CHESTER MAIN ESTATES

EAST and WEST

EASTERN CONNECTICUT ENVIRONMENTAL REVIEW TEAM REPORT

January 1995

Figure 6

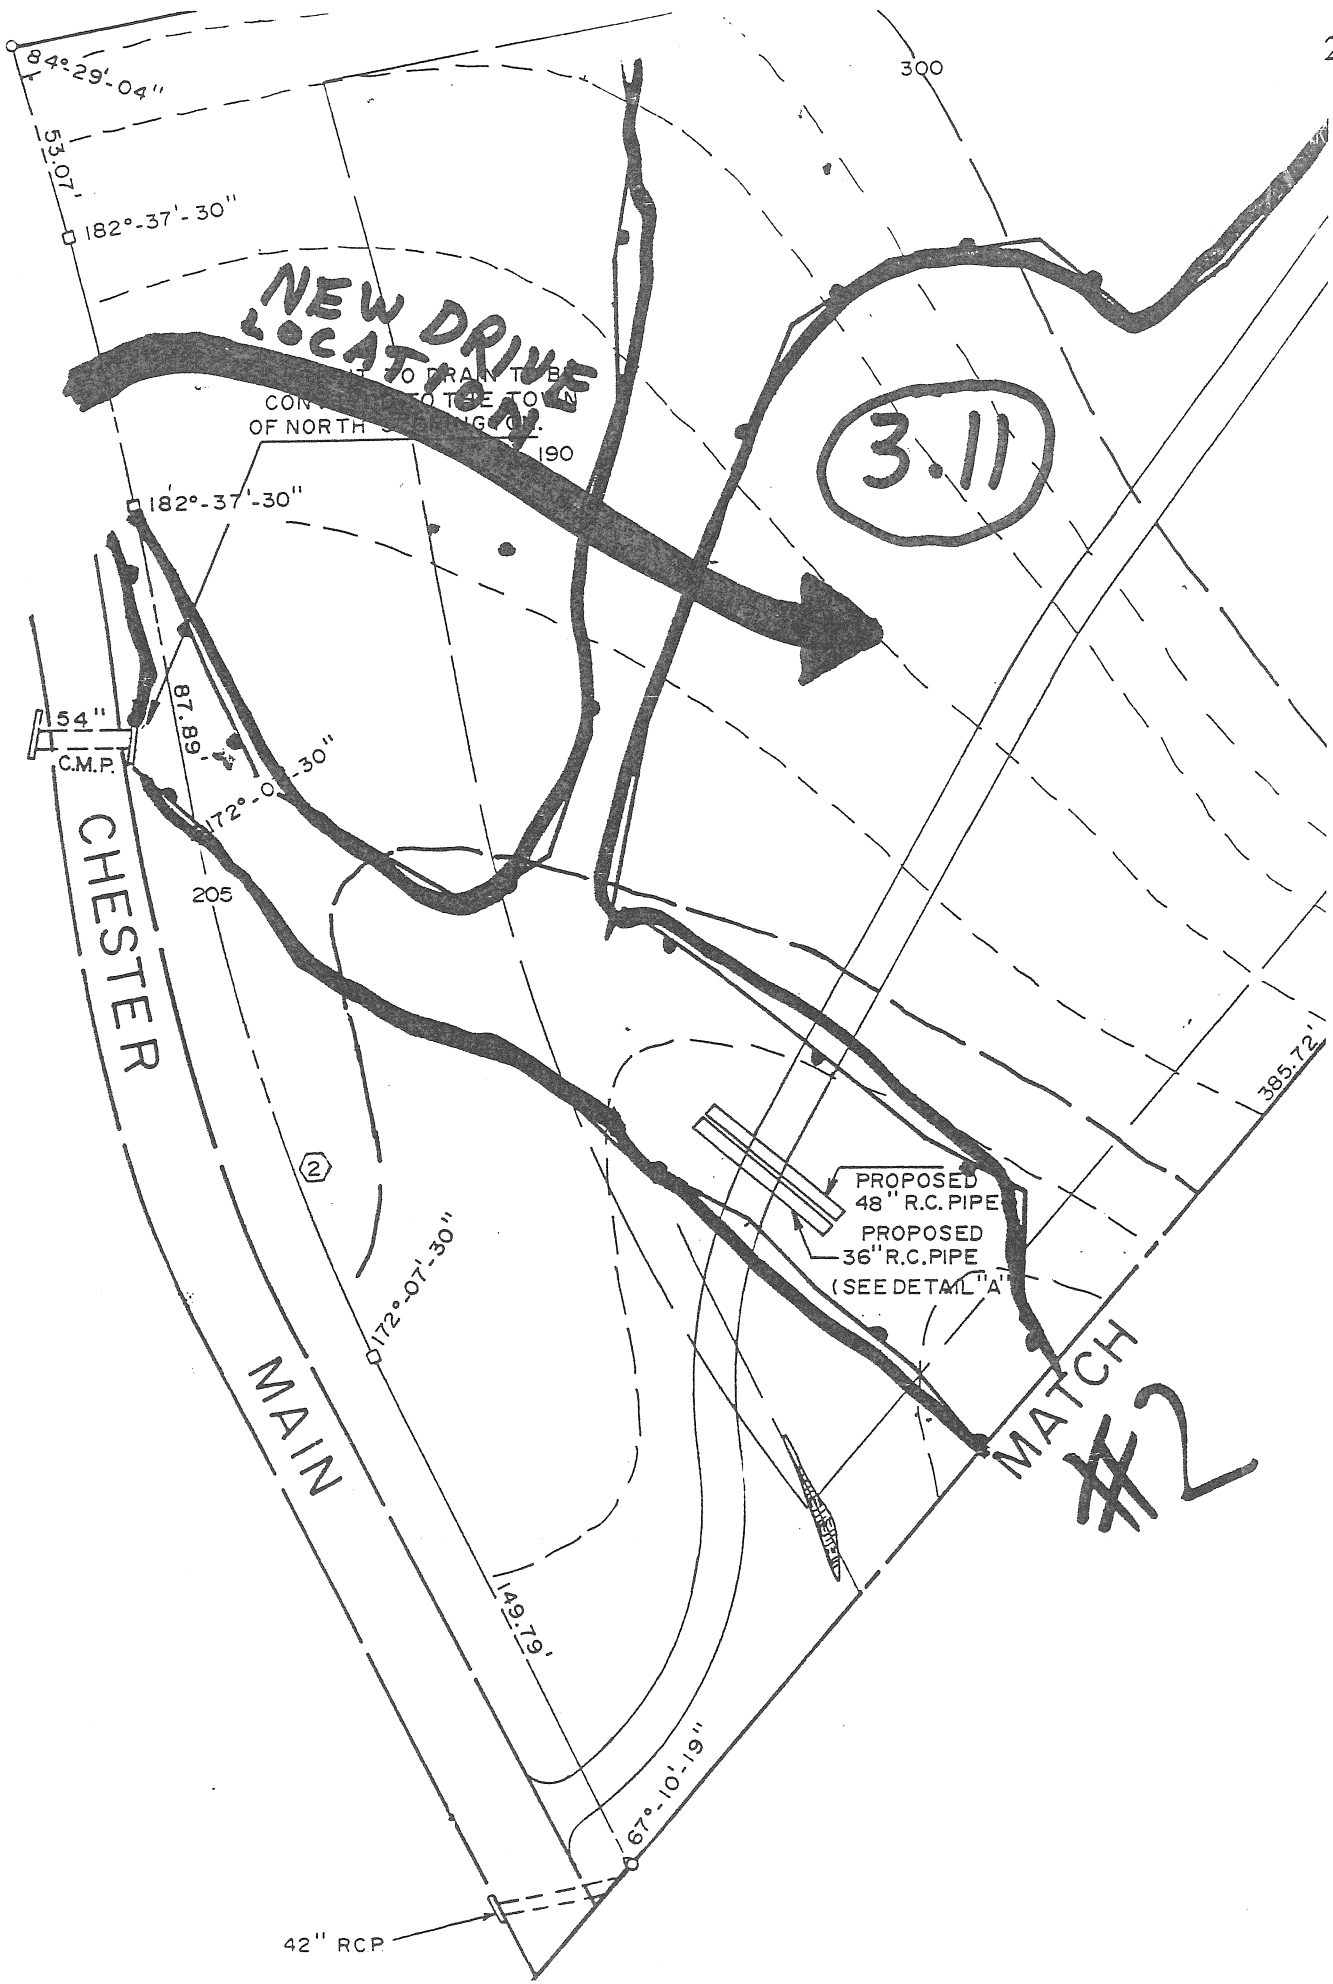
Lot 3.11- The driveway access to Chester Main Road approximately 400 feet to the north (see Figure 6) could be relocated. The drive could follow the contour and cross the narrower wetland "arm" leading down to the main channel. With less flow in the

channel, the size of the downstream erosion protection rip-rap pad should decrease. The overall length of the drive should also decrease using this arrangement. However, constructing the drive along the contour may require more fill on the down-gradient side as it crosses the wetland. If the approved crossing is to remain, consider the use of a larger arch culvert, pre-cast box culvert or timber bridge here. These options reduce or eliminate the amount of fill necessary for the crossing, should eliminate the need for the downstream rip-rap pad and preserves stream-bottom characteristics as the watercourse flows under the drive.

Figure 7

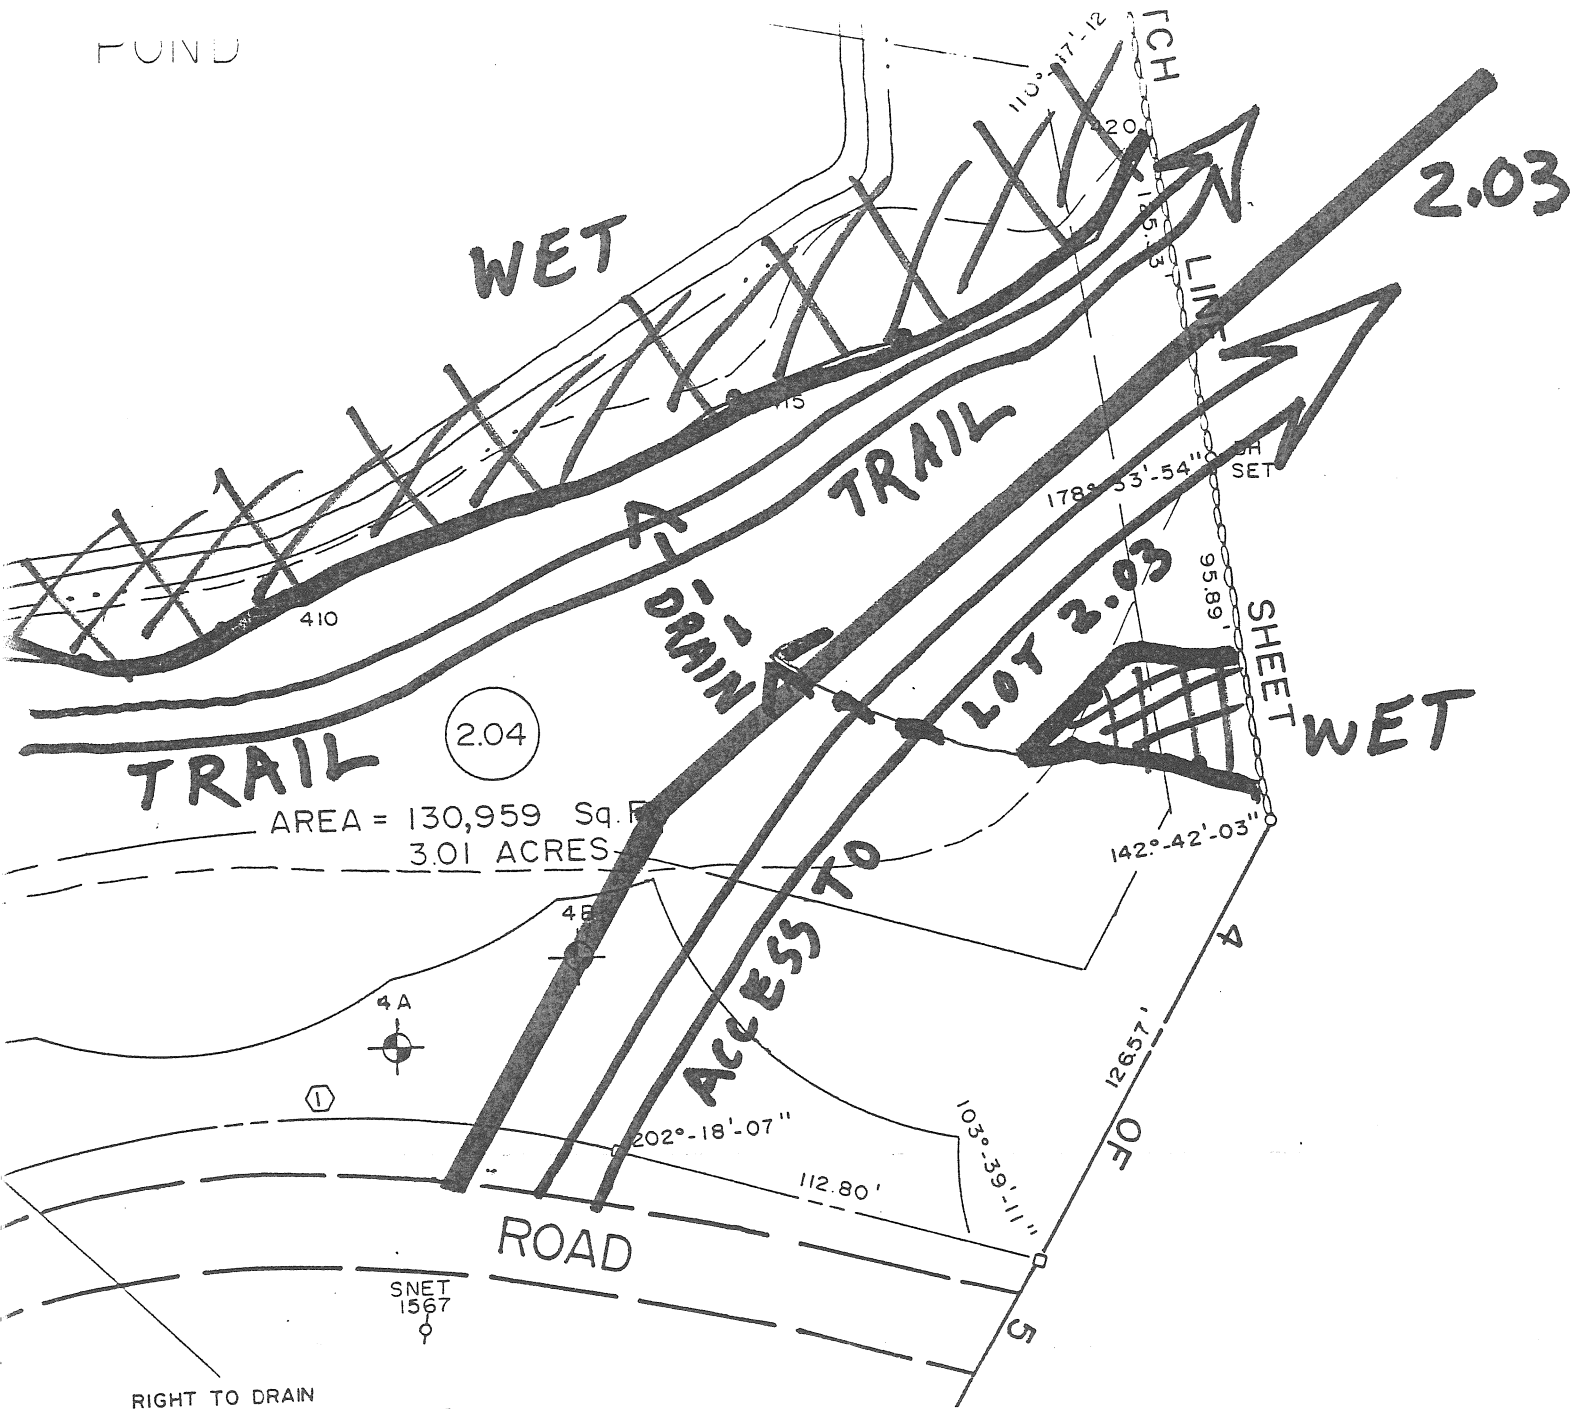
Lot 2.03 - Re-arrange the side lot line so that access to Chester Main Road is 340 feet farther to the south onto what is now lot 2.04 (see Figure 7). Continue north to the upland area between the pond and other wetland area to the east (wetland flags 440 through 507). While inspecting this area in the field, it was evident that during high water periods, surface water flow from this wetland area traveled overland to the pond. If the drive is to be relocated to this position, a culvert would be necessary to accommodate this flow. See open space discussion on lot 2.04 below.

Figure 9

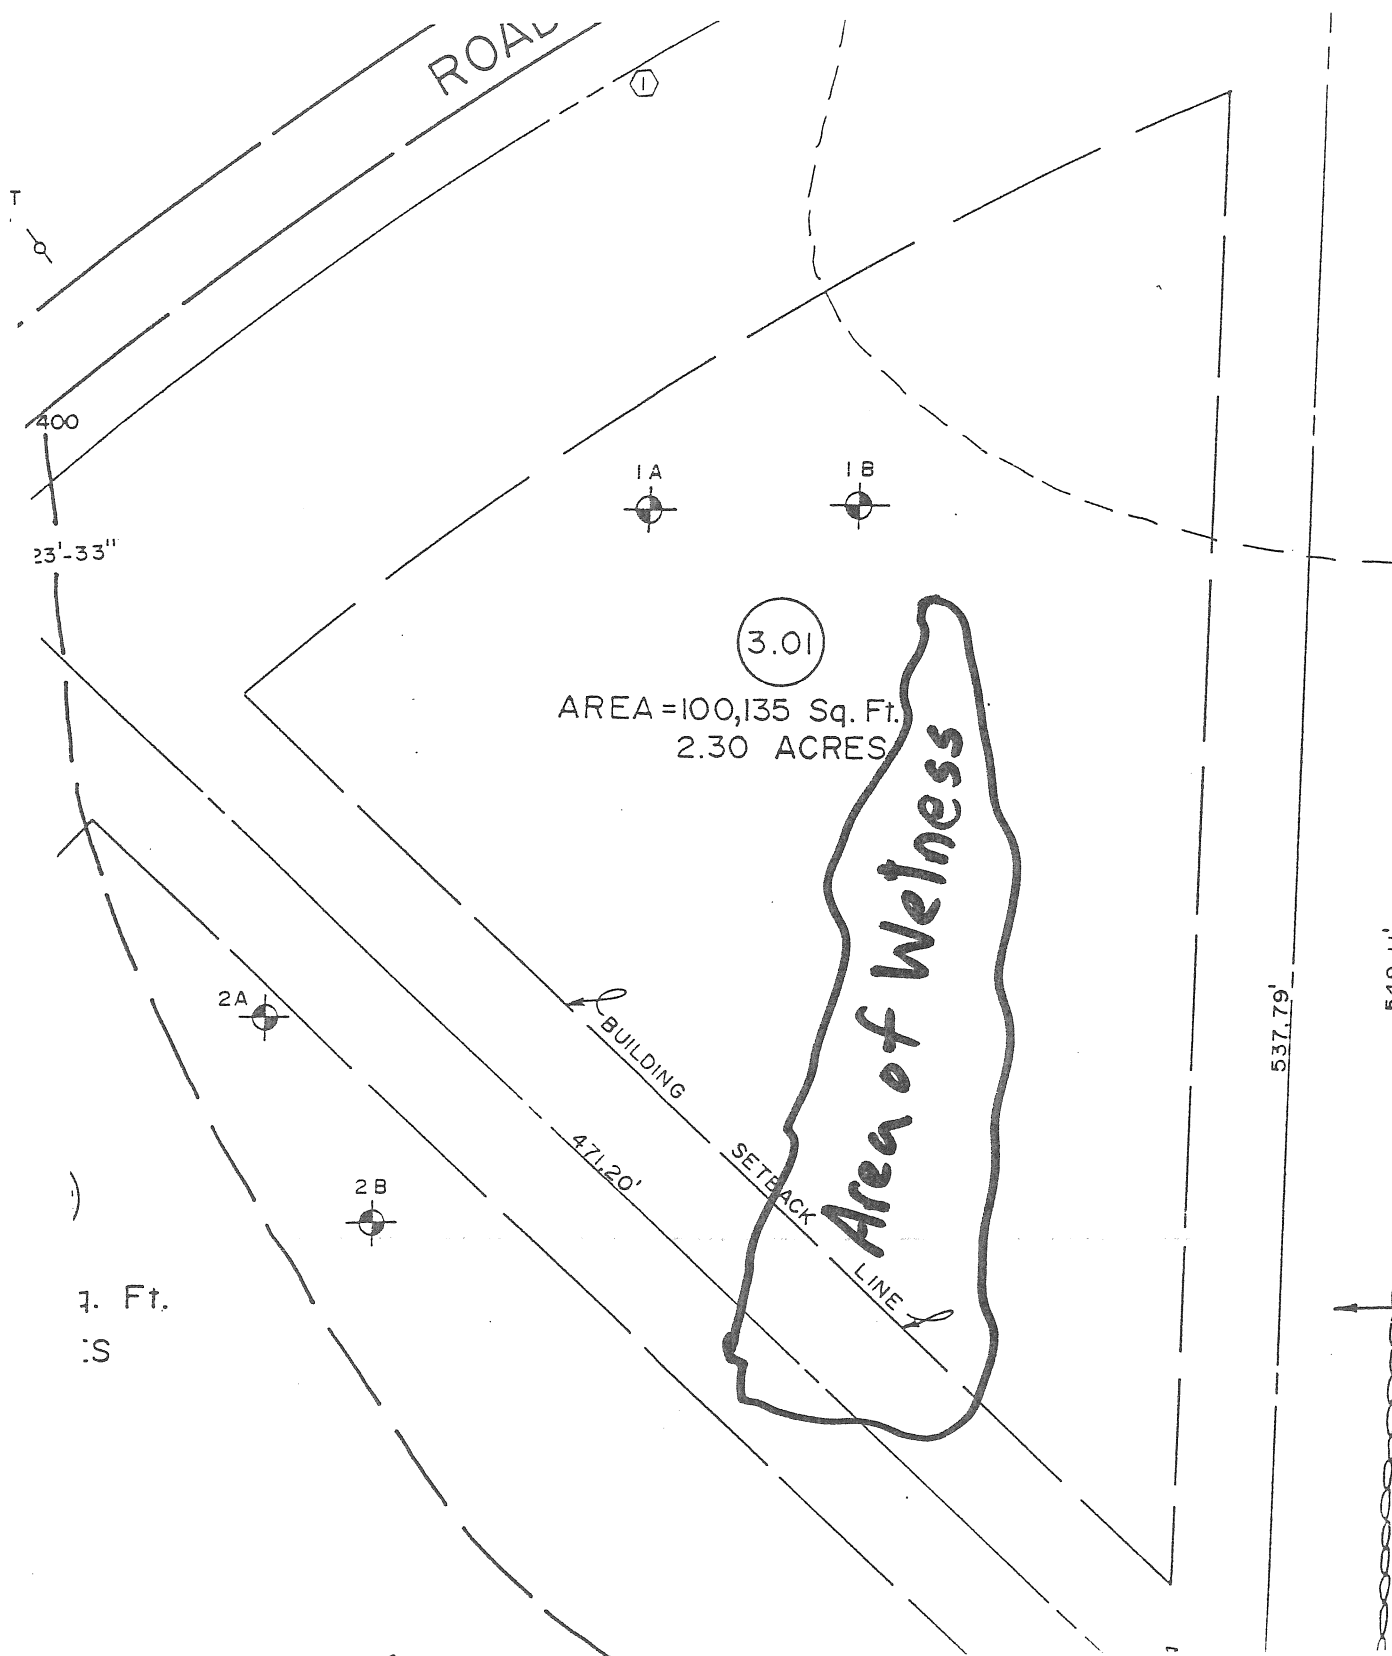
well-defined drainage-way on lot 2.08 is clearly visible on aerial photographs. While this may not have all the usual characteristics of a watercourse, its presence should be noted on the site plan so that future septic and house locations can be sited accordingly (see Figure 8). Similarly, there are wet areas visible on aerial photographs (dated 4/9/90) in the area proposed for lots 3.01 and 3.02. They appear to be located southeast of test holes 1B and 2B (see Figure 9).
